AIRWORTHINESS DIRECTIVE - GLIDERS

GFA/AD 16B/LET N.P. KUNOVIC 4

Glider Types Affected - L-13 Blanik, up to Serial No. 173414

EXTRACT OF SERVICE BULLETIN NO. L.13/025

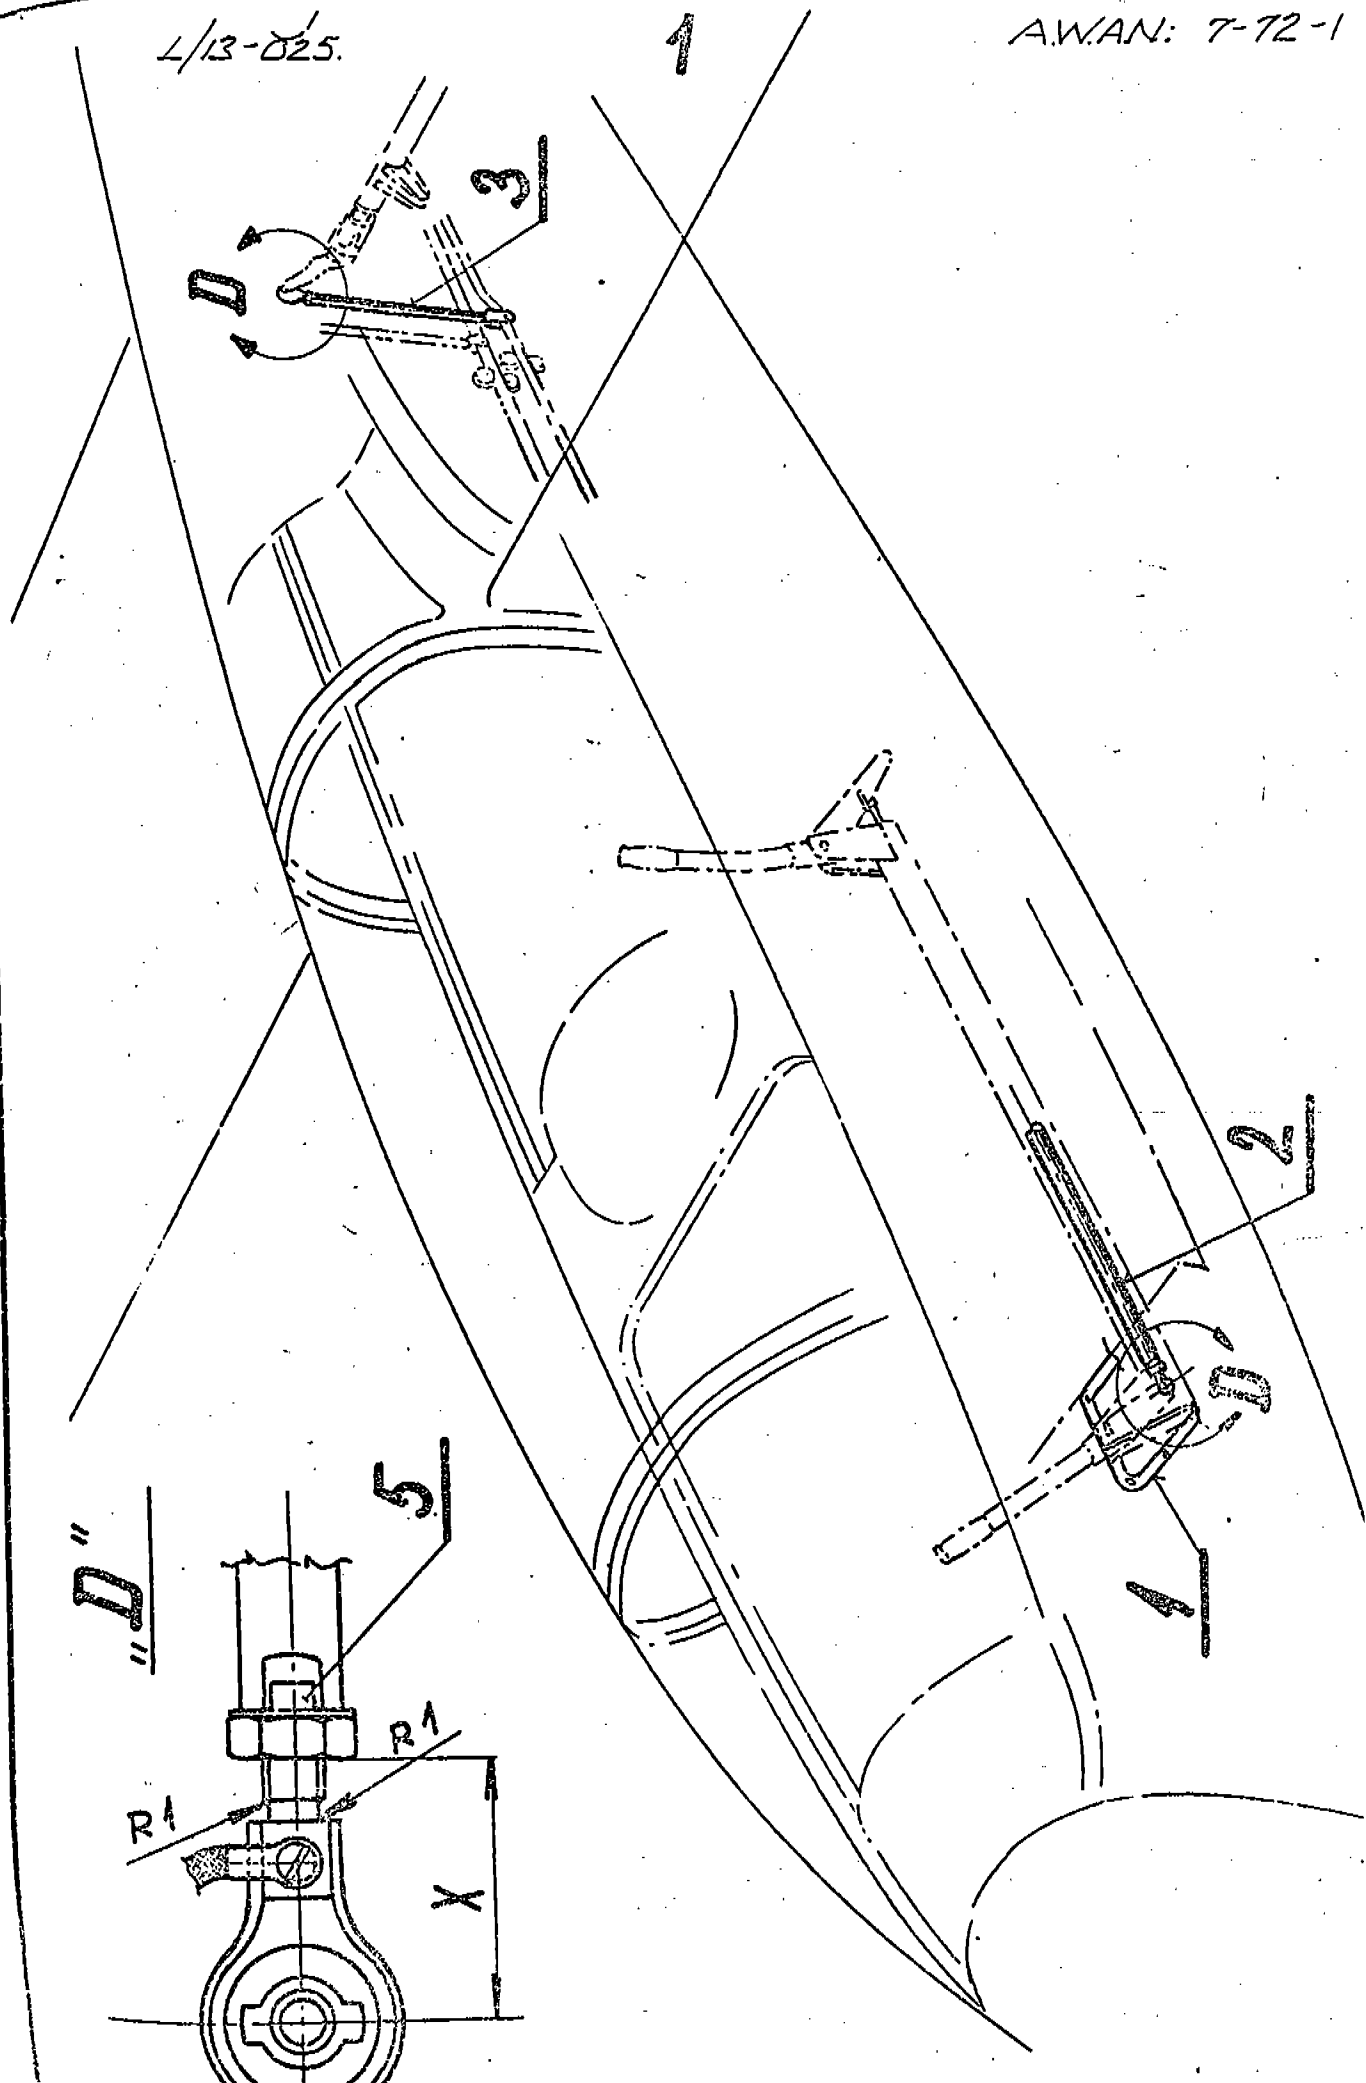
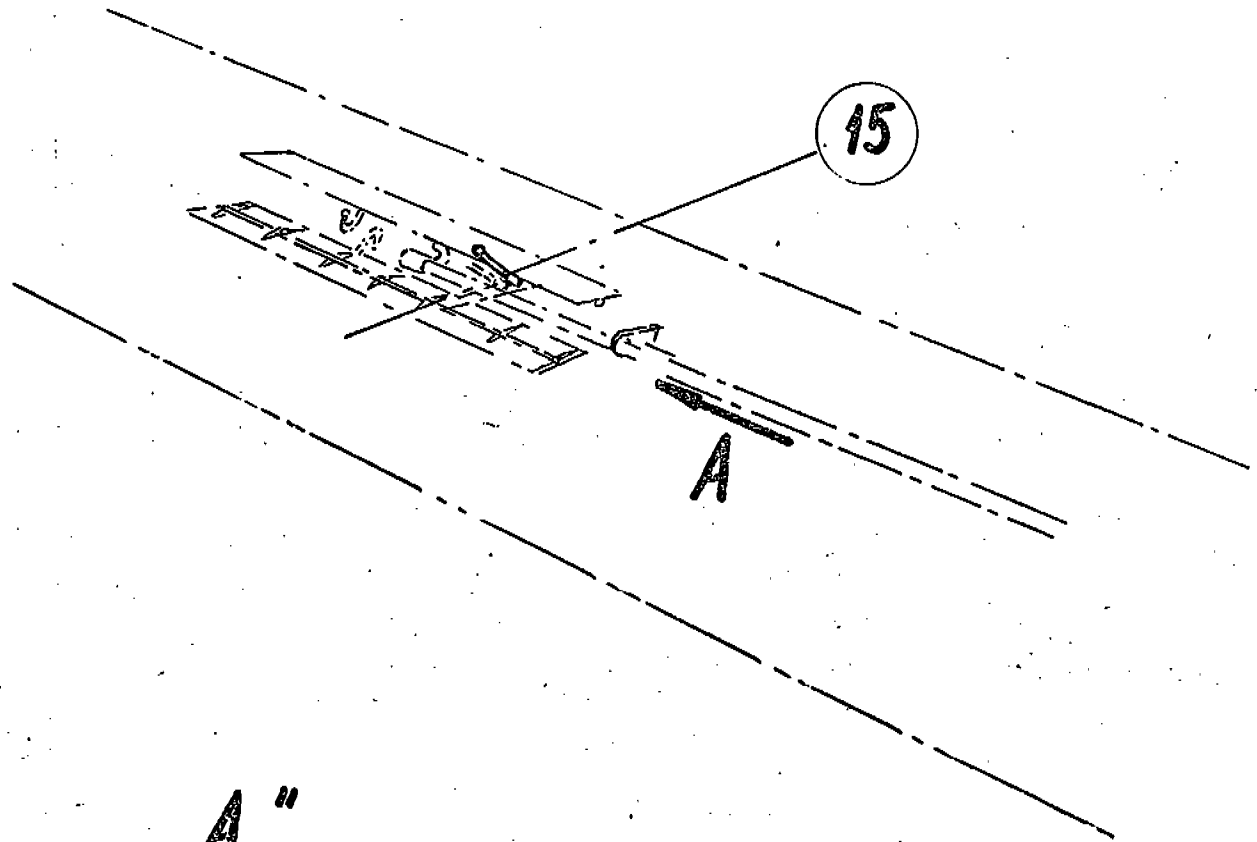
Before further flight unless the required inspection has previously been carried out, inspect the control rod ends at the elevator push rod at the base of the front cockpit control column, the push rods in the fuselage centre section and the dive brake actuating rods (see illustration).

Remove the frame and control column boot from the front control column. Check the rod end of the push-pull rod to ensure that the radii at the recess at the end of the thread is 1 m.m. - 0.040 inches if the corner radius is less than 1 m.m. or is sharp the rod end must be replaced. Inspect also the push rod ends in the fuselage centre and in the wings near rib 15.

If the lock nut is close to the shoulder so that the recess cannot be properly inspected it will be necessary to release the lock washer and remove the rod end as the tab washer cannot be re-used.

In order to avoid resetting the control rods, measure the distance "x" in view "D" replace rod end with new tab washer in place and adjust to the same dimension and lock with nut and tab washer.
